BUILDING PERMIT APPLICATION

Project Address / 226 W. TNdiANTOWN PD Permit No. -00 - 54220

Building C

Permit # 0054220

CLARIFICATION

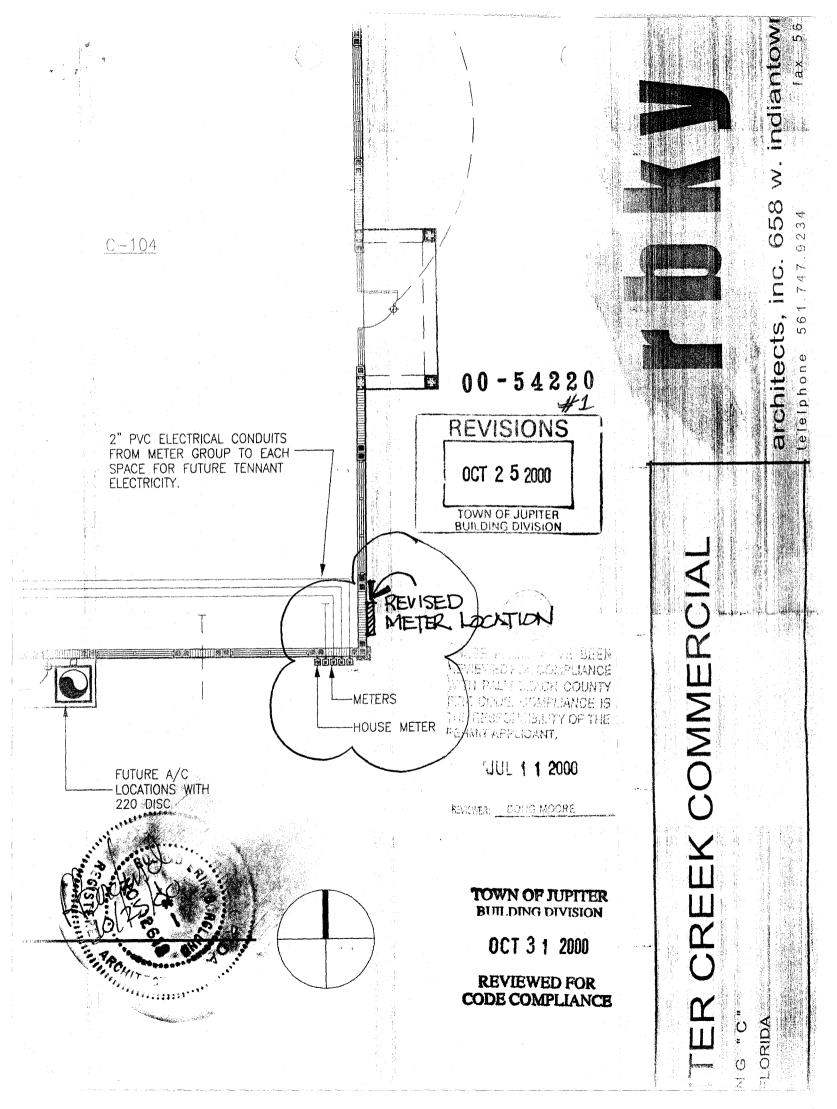
Please note that the meter bank for this building is to be relocated to the east face of the southeast corner of the building instead of the south face of the same corner. See attached sketch. If you have any questions or comments, please call me.

REVISIONS

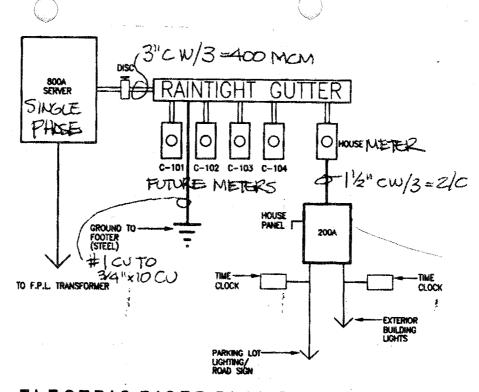
- 1. Planning, Zoning, Engineering, approvals are not complete.
- $O\not\vdash 2$. Soil analysis and densities.
- C(4, 3. Truss layout by truss company supplying trusses to job.
 - 4. Electrical:
- 1. Riser does not show:
 - A. Specification for main disconnect.
 - B. Conduit and wire size.
 - C. Detail of ground system.
- 2. No panel schedule for house panel.
- 3. No location of house sub panel.
- 5. Plans as submitted are for "shell only", any additional work shall be defined on additional permits.

- 1. So noted
- 2. Soil analysis and densities will be submitted
- 3. Truss layout will be submitted
- 4. Electrical riser modifications attached.
- 5. Plans as submitted are for shell only.
- 6. The building occupancy is Group "B"
 Construction is type "V" unprotected
 Building has a total of 8706 sf

EXTERIOR ELEVATIONS: BUILDING "C"

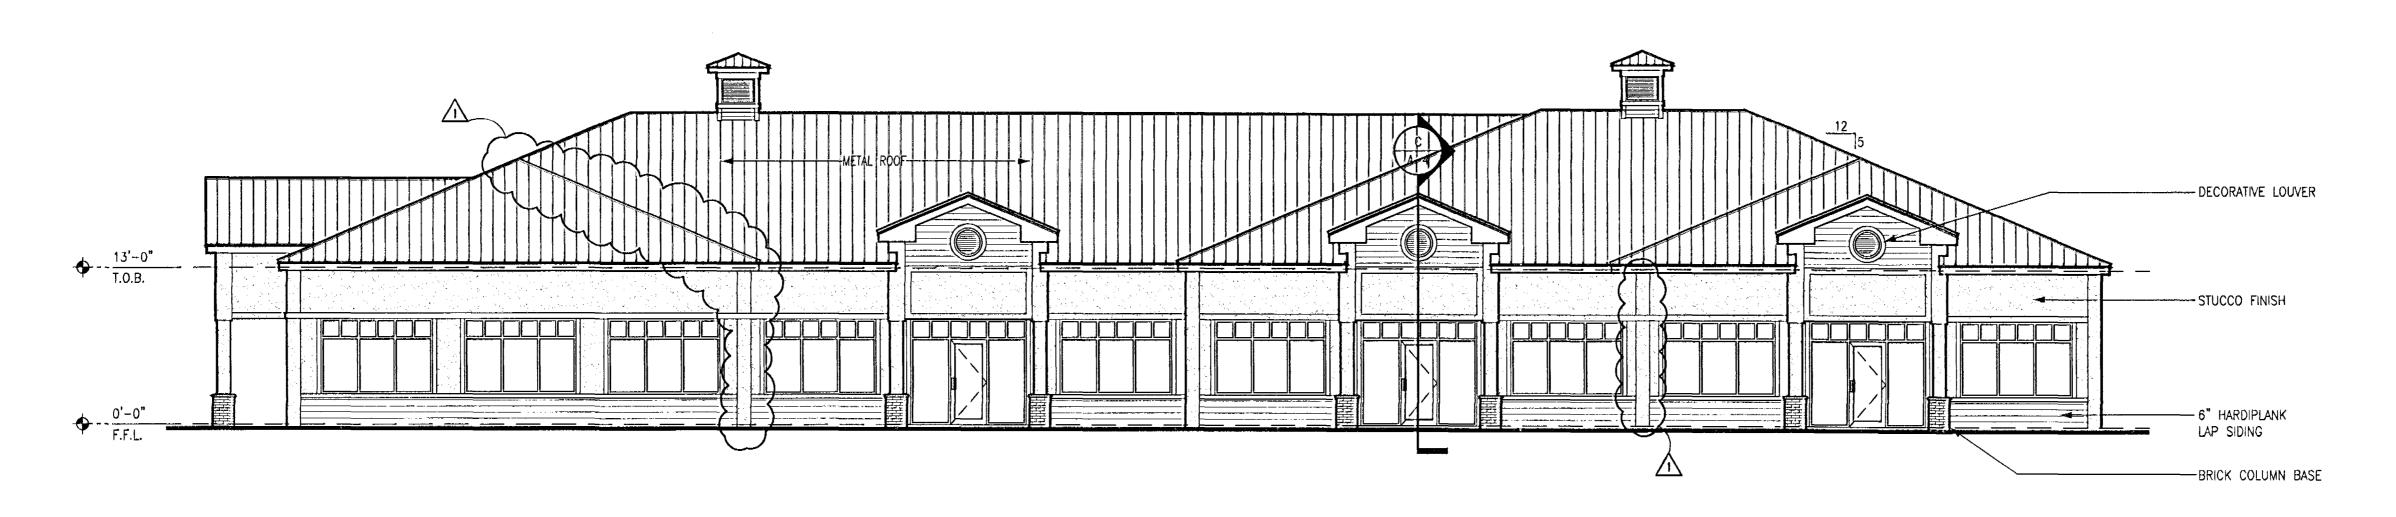
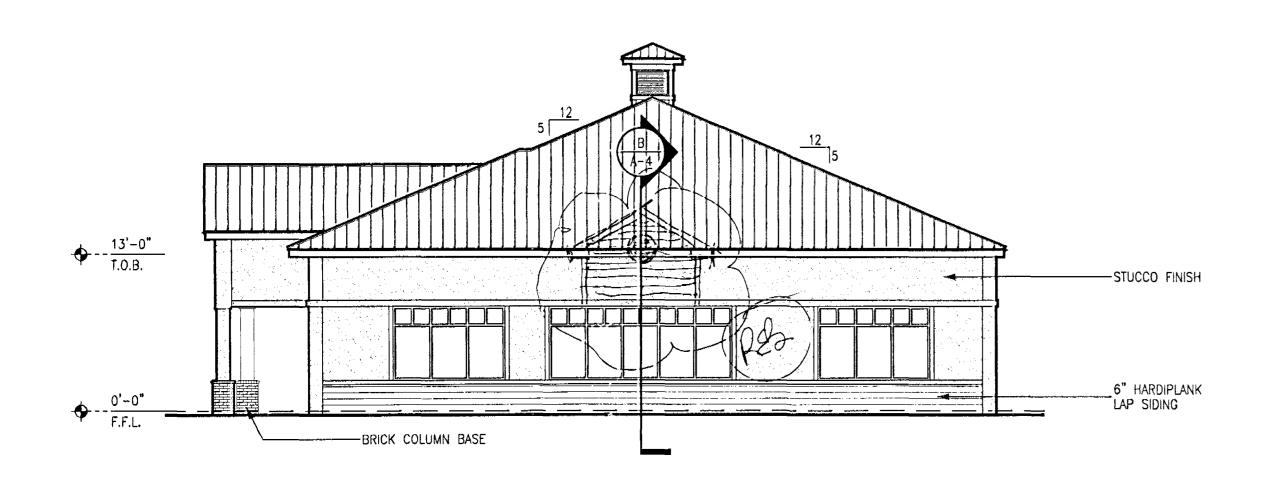
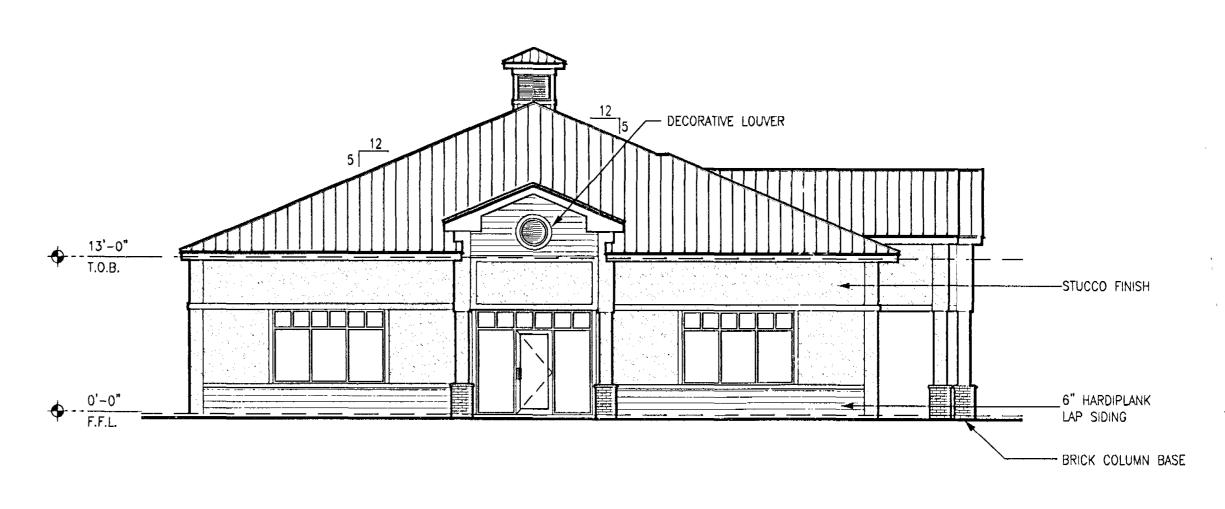
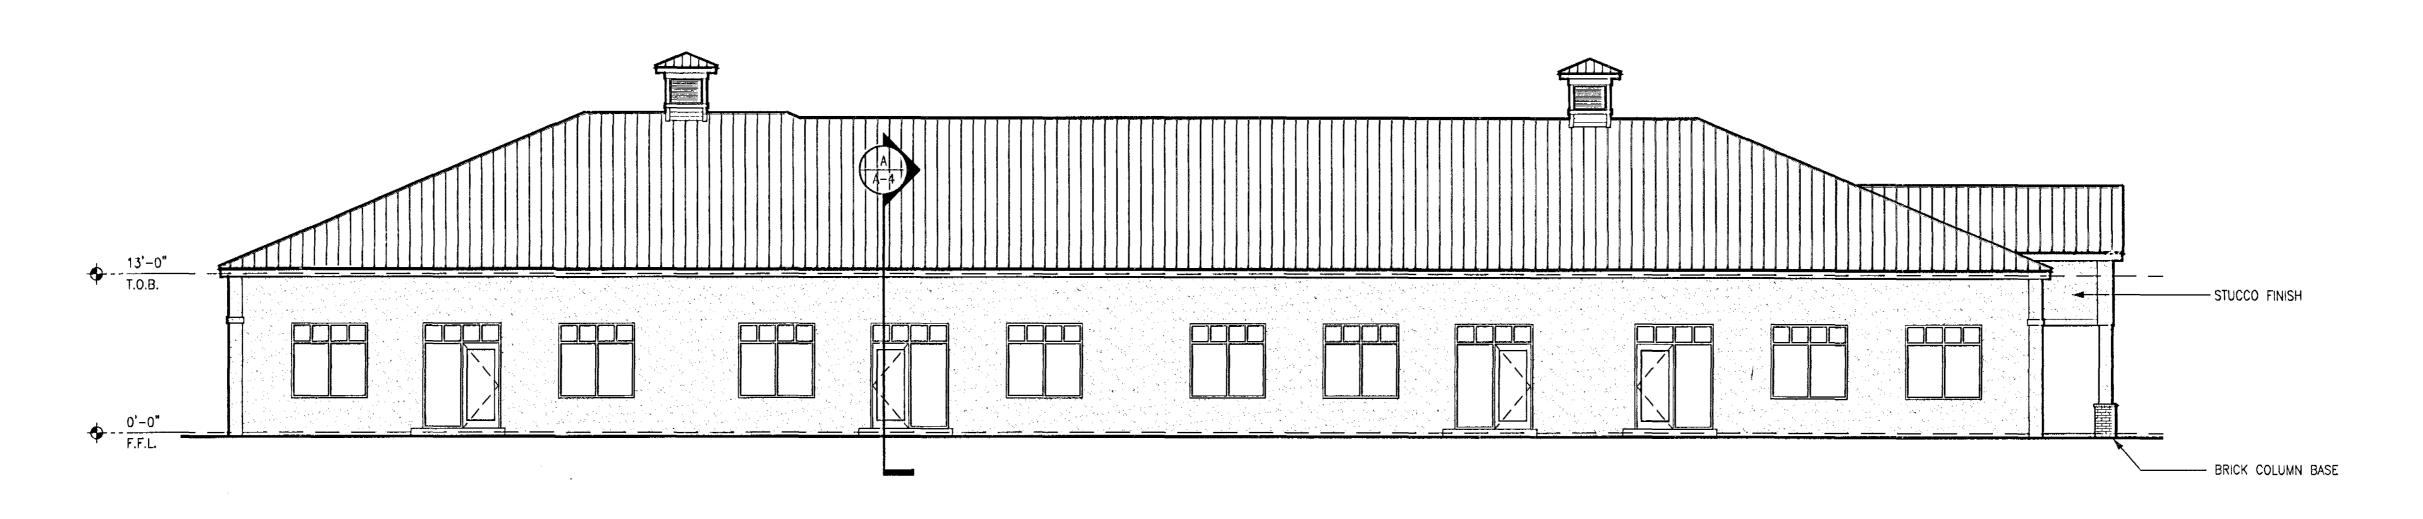
THE APPLICANT MUST REVISE THE FINAL PLANS TO REFLECT THE PROPOSED ELEVATIONS INCLUDED WITH THIS PERMIT, PLEASE REVISE ACCORDINGLY / BK . FOR MORE INFORMATION CONTACT BRIAN KLUTTZ @ 741-2427
